Landscape Architecture

AM Blocks Narrative regarding fourteen (14) drawings attached being modified with date 9-22-2020. These sheets are being modified to allow curvilinear Abernethy landward bonus plazas with expanded lawn that flows up to meet bonus plazas providing more welcoming spaces from the trails that are easily accessed by pedestrians. Reference drawing C.216 Subarea 3 that indicates that 80% of Subarea 3 is still being provided as required, that 60% of required landscape is planted in shrubs, and revised tabulation is provided for ground cover. These calculations are over minimum required. Exhibit C.219 indicates that to provide shrubs over required, some ground cover was reduced and some shrubs were increased. These two (2) above mentioned drawings can be compared to same drawings dated 6-22-2020. Drawing C.218 indicates that trees remain unchanged – this drawing has been re-submitted as Bonus area and maker's plaza have changed.

GREENWAY REVIEW # (LU-20-102914 DZM GW) EXHIBIT C.215

LANDSCAPE - GREENWAY PLANTING PLAN- NORTH

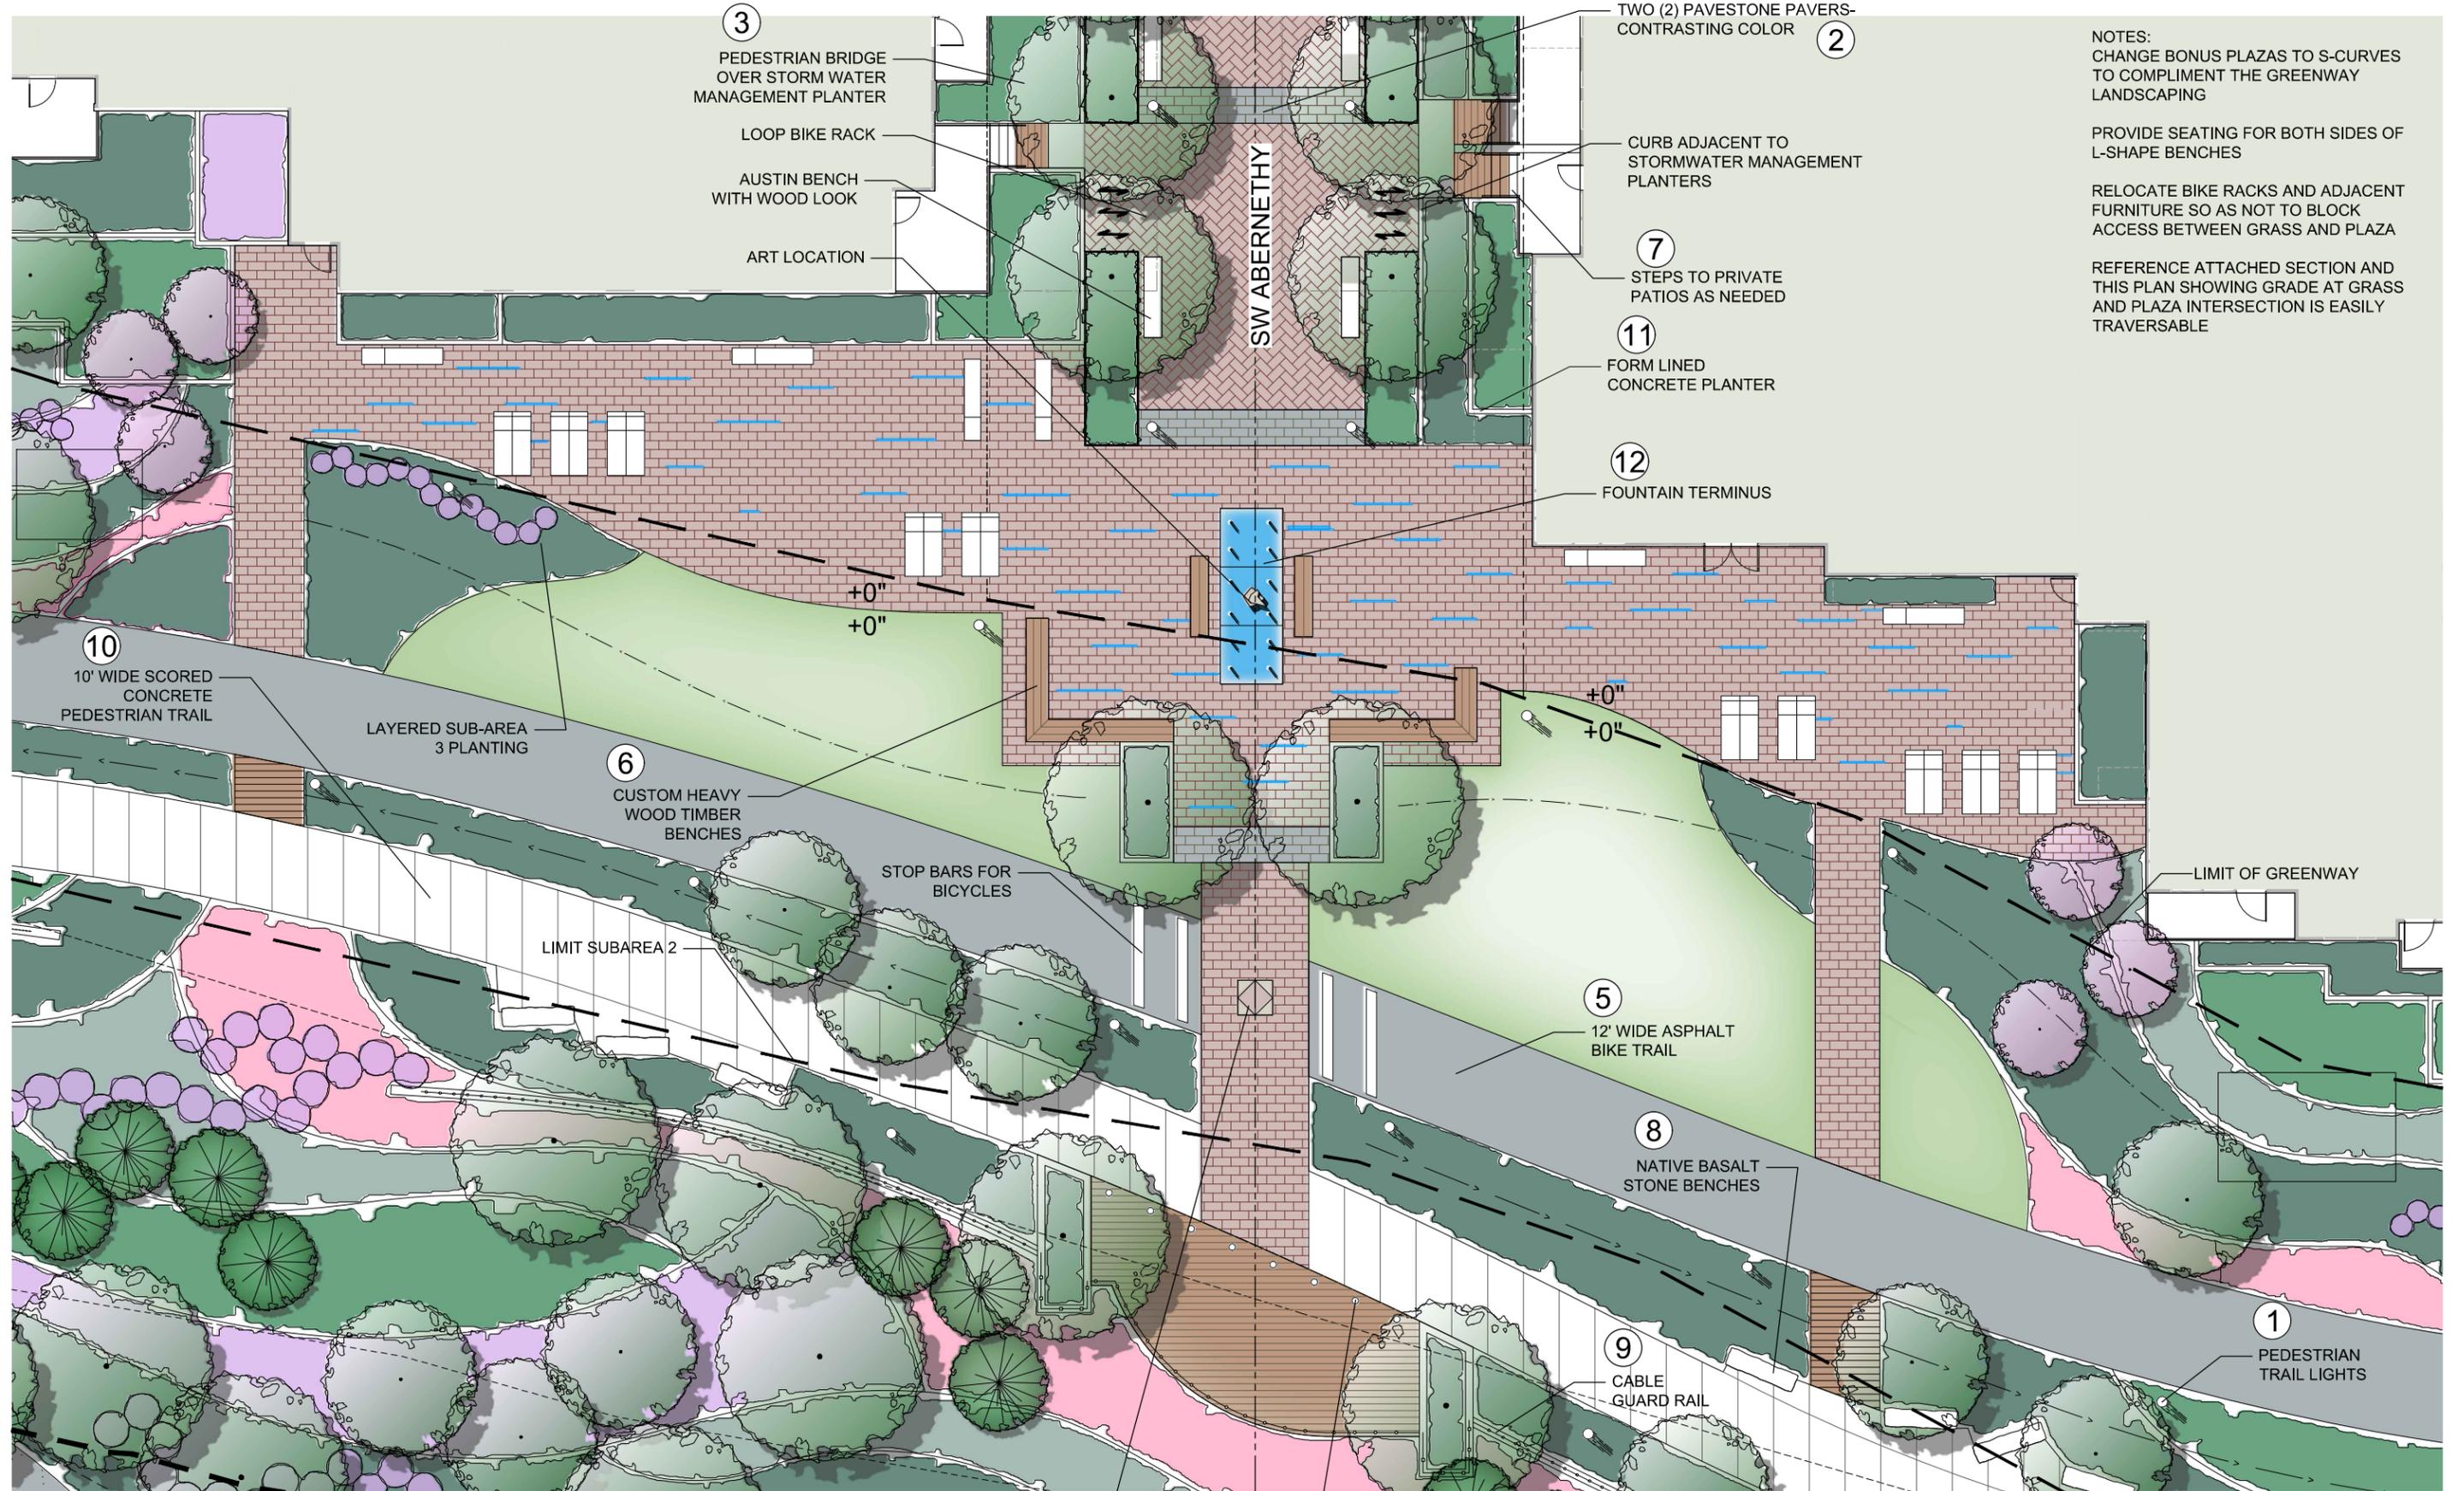
NOTES:
 CHANGE BONUS PLAZAS TO S-CURVES TO COMPLIMENT THE GREENWAY LANDSCAPING
 PROVIDE SEATING FOR BOTH SIDES OF L-SHAPE BENCHES
 RELOCATE BIKE RACKS AND ADJACENT FURNITURE SO AS NOT TO BLOCK ACCESS BETWEEN GRASS AND PLAZA
 REFERENCE ATTACHED SECTION AND THIS PLAN SHOWING GRADE AT GRASS AND PLAZA INTERSECTION IS EASILY TRAVERSABLE
